# Heater Return Pipe

# TSB-83-164-FTL

**Description of Revisions:** This bulletin replaces the version dated 2025-07-22. The list of affected vehicles has been revised.

Fig. 1, Coolant Leak Location

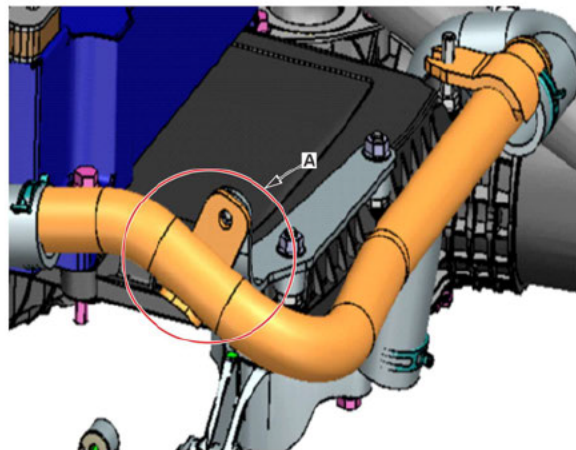
The field received complaints about obvious coolant leaks on the heater return pipe from the weld-on bracket that attaches to the engine bracket. This condition is observed most often on vehicles equipped with DD13 engines. This service bulletin is applicable when there is visible coolant leakage from the tubes and engine side.

1.  Inspect the front right-hand side of the DD13 engine heater return pipe for coolant leakage. See Fig. 1.

A. Check this area for coolant leaks from the heater return pipe.

2.  If coolant leaks are found, drain or adjust the coolant level as required.

3.  Replace the old heater return pipe with the updated part. **Do not** replace the right-hand side bracket.
